CITY OF MOUNTAIN VIEW

CALIFORNIA HIGH-SPEED RAIL PROJECT

COMMENTS ON THE PRELIMINARY ALTERNATIVES ANALYSIS REPORT

This letter transmits, on behalf of the City Council, the City of Mountain View's comments on the Preliminary Alternatives Analysis Report (AA) for the High-Speed Rail (HSR) project. In addition to these comments, enclosed are completed Exercise 1 and Exercise 2 from the Context-Sensitive Solutions Toolkit. These comments were approved by the Mountain View City Council on June 22, 2010.

MOUNTAIN VIEW HIGH SPEED RAIL | CHSRA/PRP CSS TOOLKIT EXERCISE I

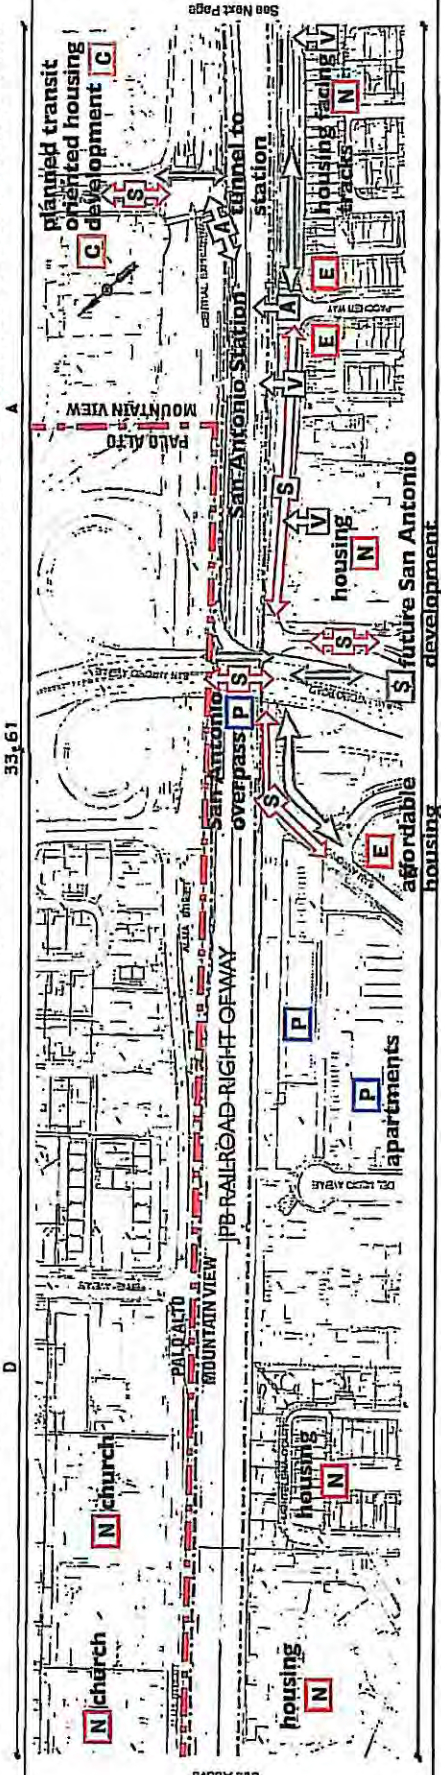
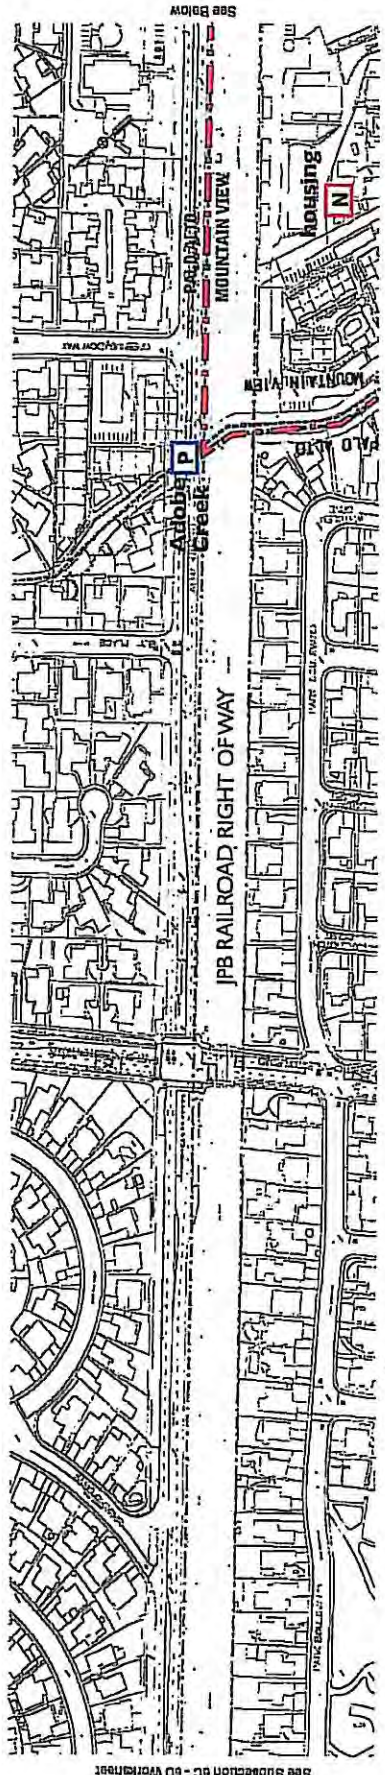
- Maintain safety, station accessibility & connectivity to existing performing arts & future development of San Antonio & shopping center; existing neighbors along Showers Drive & Central Expressway
- Maintain pedestrian/bicycle access tunnel at San Antonio Station. An extension of the pedestrian/bicycle underpass under Central Expressway to connect to new housing and neighborhood is planned.

MOUNTAIN VIEW HIGH SPEED RAIL | CHSRA/PRP GSS TOOLKIT EXERCISE I

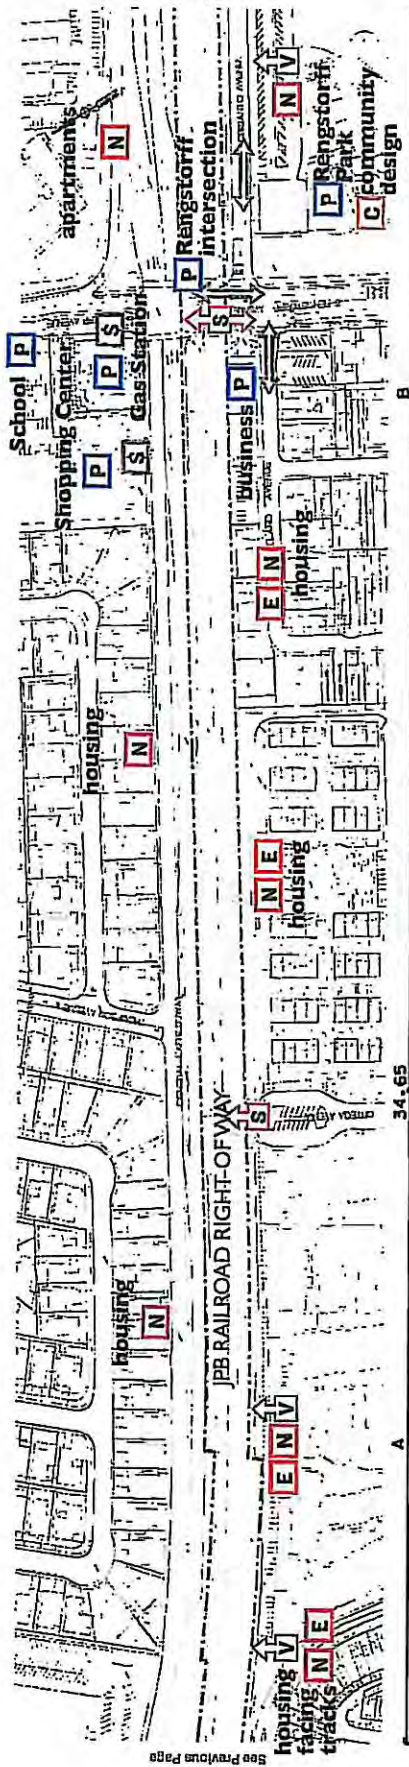
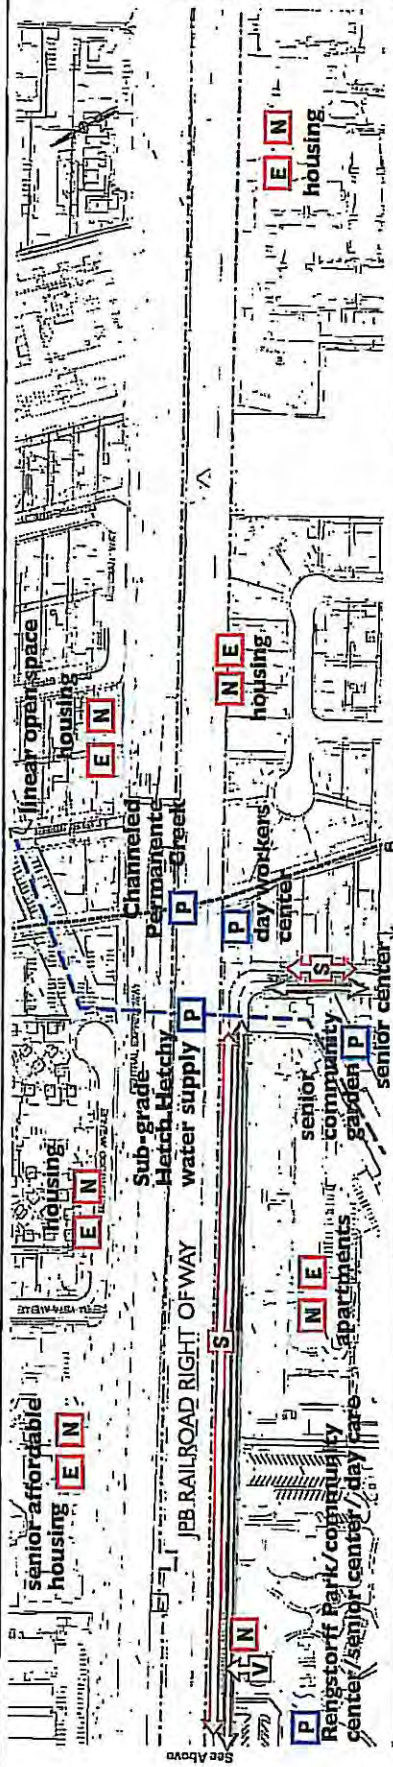
- Safety and connectivity to Rengstorff Park, senior center, senior gardens and day workers' center.
- Conflicts with Permanente Creek culvert and PUC Hetch Hetchy waterpipes.
- Improve safety and connectivity at rail/Rengstorff/Central Expressway intersection.

MOUNTAIN VIEW HIGH SPEED RAIL | CHSRA/PRP CSS TOOLKIT EXERCISE I

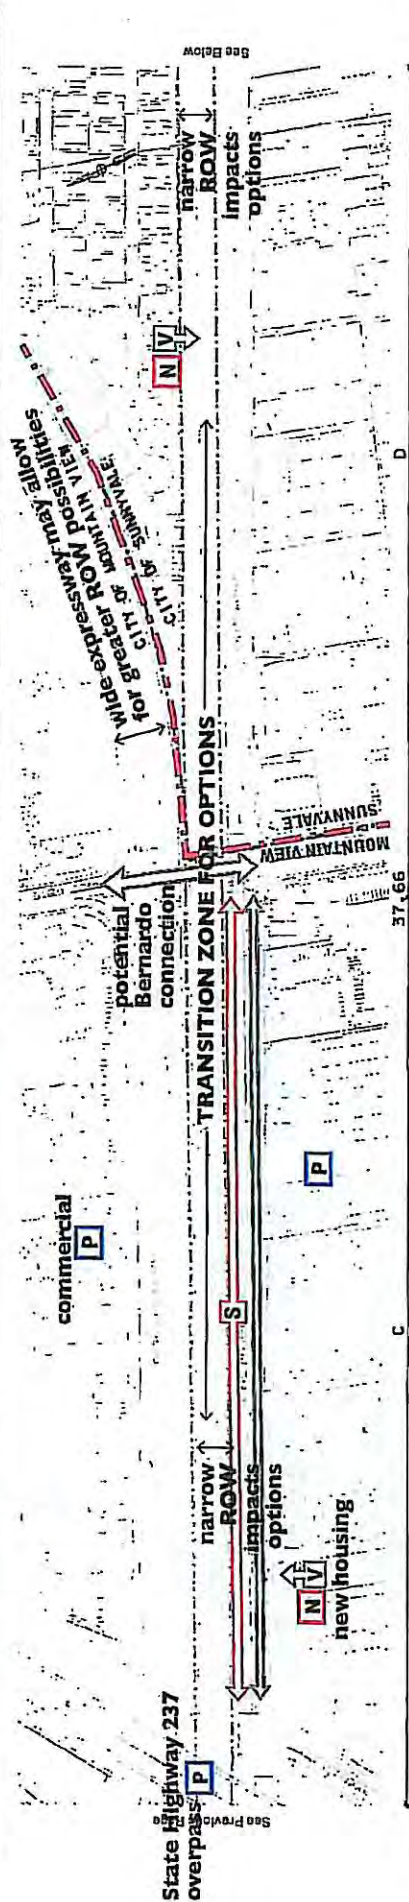
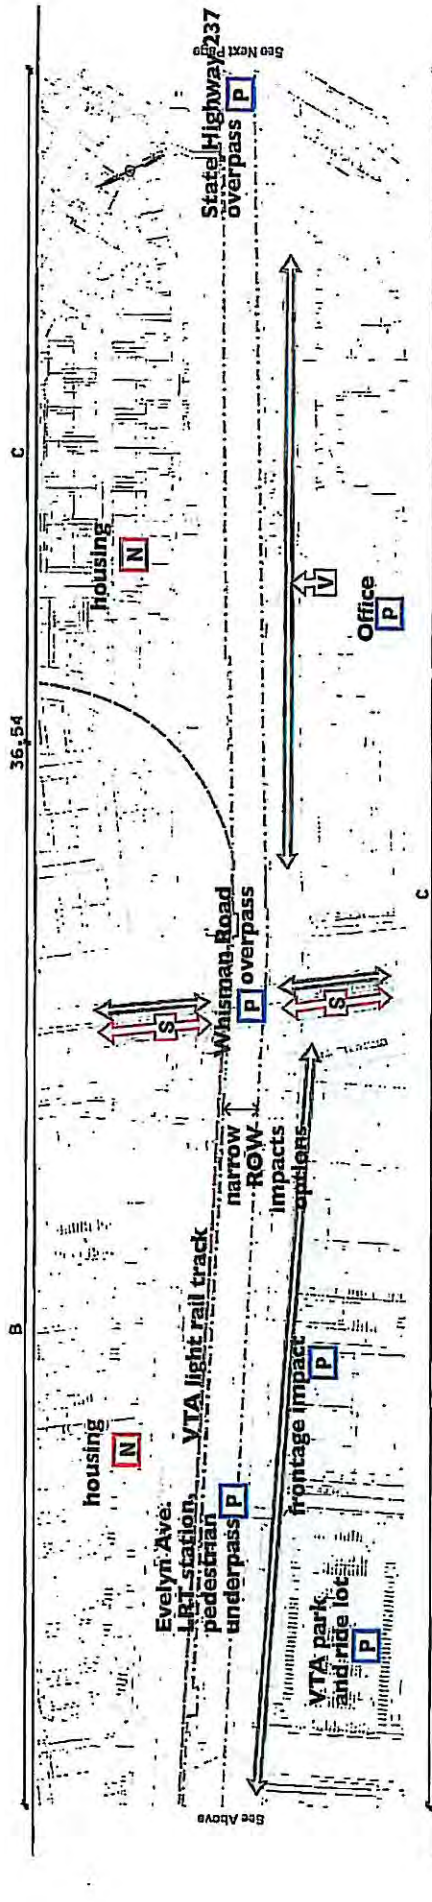
- Maintain safety and connectivity on Whisman, required.
- How will VTA light rail station/pedestrian underpass integrate with HSR at grade?
- Bernardo - not currently connected over Central Expressway - possible improvement (bike/pedestrian or vehicle).

CITY OF MOUNTAIN VIEW - HIGH SPEED RAIL ANALYSIS
 CASTRO ST. TRENCH ALTERNATIVE
 DATE MAY 10, 2010

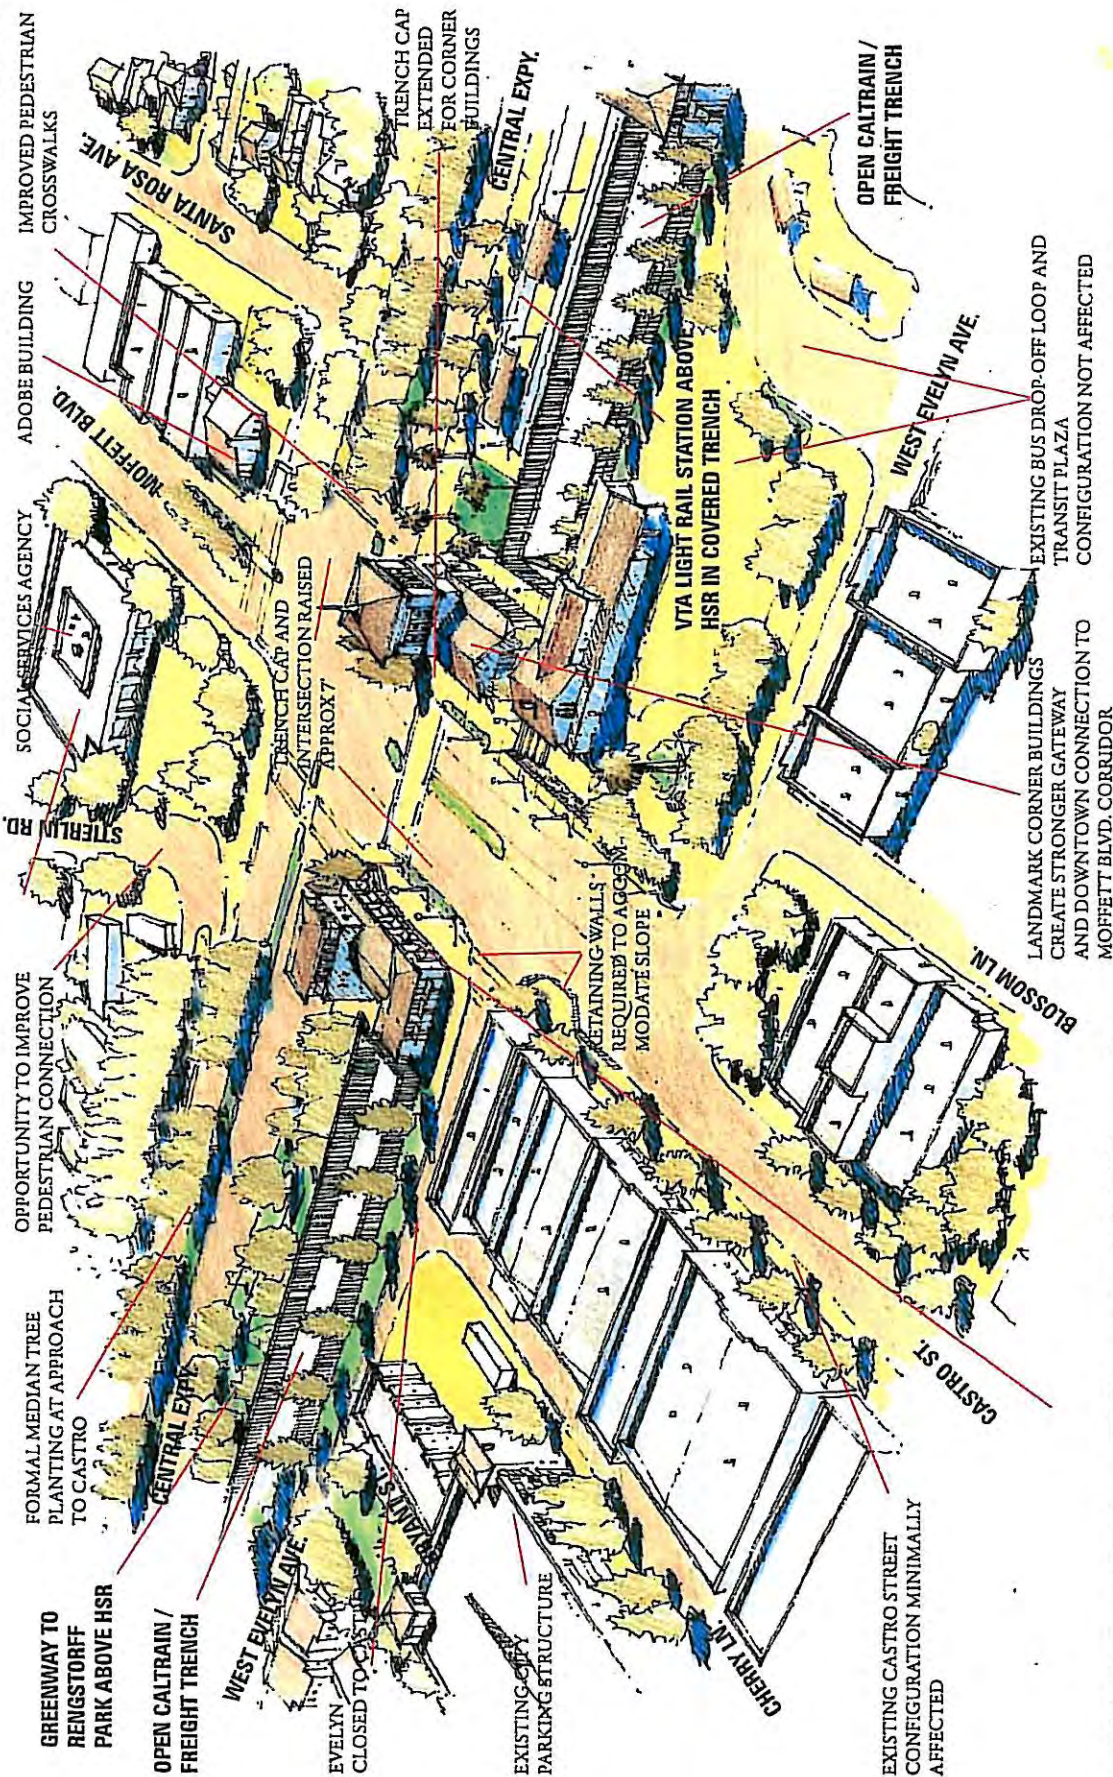
8. Enclosed with this letter are renderings prepared for the City of a partially covered trench alternative at Castro Street and at Rengstorff Avenue. The rendering shows the HSR tracks covered to provide a linear greenway between Castro Street/downtown and at Rengstorff Avenue. This greenway could provide an off-street, alternative transportation route between downtown and the Downtown Transit Center on the south and one of the City's community parks, the Community Center, the Senior Center and one of the City's most densely populated neighborhoods on the north. The City would like to explore this and other ideas with the Authority to provide community benefits along with the HSR project.
